Attachment 2 - Decision Plans (Amended S57(a) of the Act - 1 - 3 Harcourt Parade Cremorne

Re: Planning Permit Application PLN18/0002
1-3 Harcourt Parade, Cremorne

**YARRA PLANNING SCHEME
PLANNING APPLICATION NO. PLN18/0002
PROPOSAL: 104 ROOM RESIDENTIAL HOTEL DEVELOPMENT
ADDRESS: 1-3 HARCOURT PDE, CREMORNE**

TO: Sarah Griffiths (Statutory Planning)
FROM: Blake Farmer-Bowers (Urban Design)
DATE: 10 August 2018
SUBJECT: 1-3 Harcourt Parade, Cremorne
APPLICATION NO: PLN18/0002- Planning application
DESCRIPTION: Development of the land for the construction of a 10 storey building (plus plant deck), use of the land as a residential hotel (104 rooms), construction and display of major promotional electronic signage and removal of covenant 1818808 from lot 1 on plan of subdivision 408289Y.

Attachment 3 - Updated eastern elevation

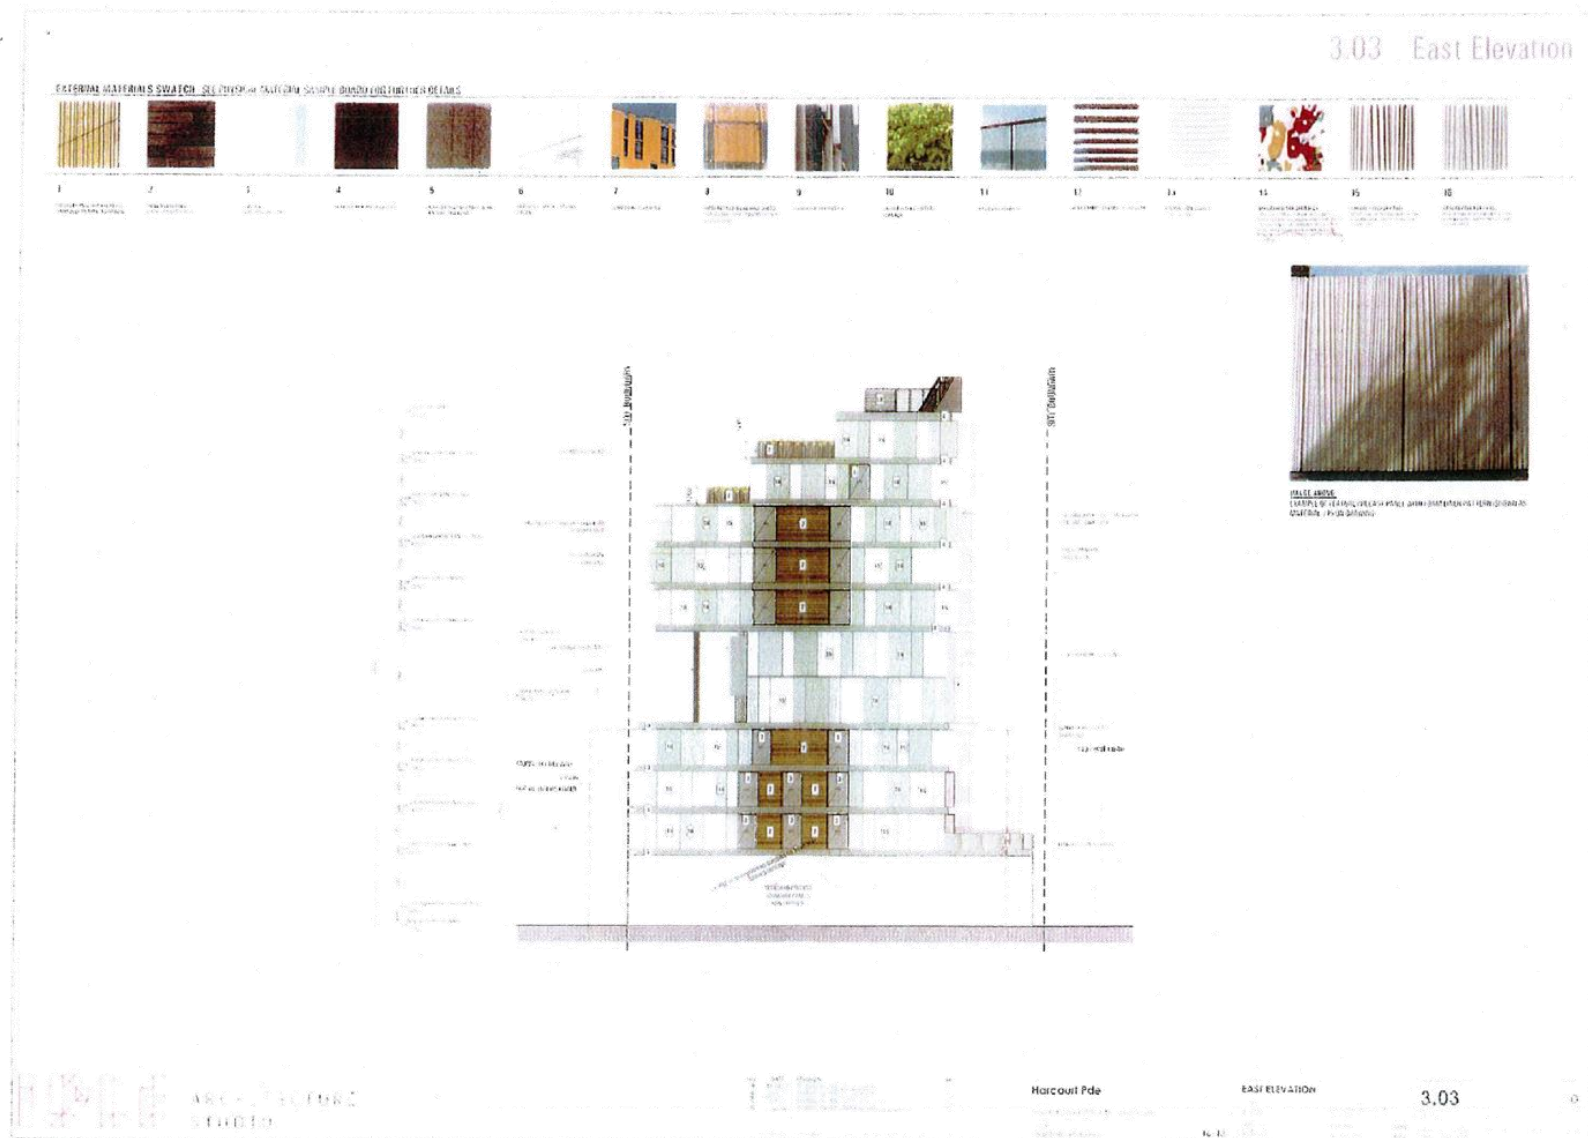
Please find enclosed an alternative east elevation (Drawing No. 3.03 Revision D) for your consideration which depicts a more complex treatment of the pre-cast concrete panels. If you consider it appropriate, our clients would welcome a condition on permit requiring it be substituted for the current east elevation.

Figure 1 – a number of spaces do not appear to have adequate clearance to function as intended.

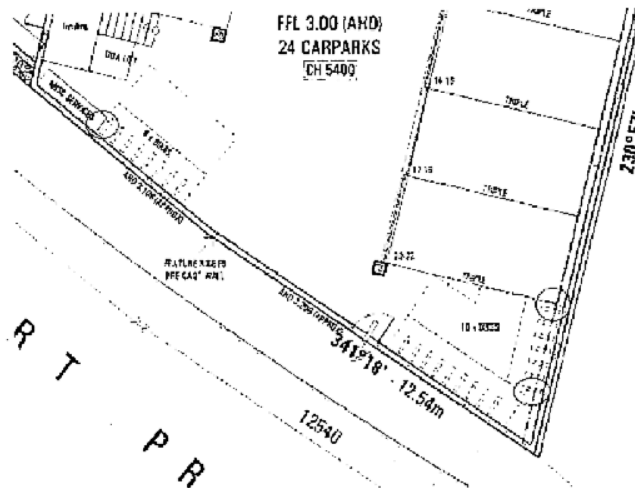
- The design and layout of the spaces requires revision given:
 - All spaces are hanging spaces. Pursuant to Australian Standard AS2890.3 at least 20% of spaces are required to be horizontal at ground-level spaces.

- A number of spaces do not appear to have adequate clearance from car parking lifts, service cupboards or each other (see Figure 1 below).
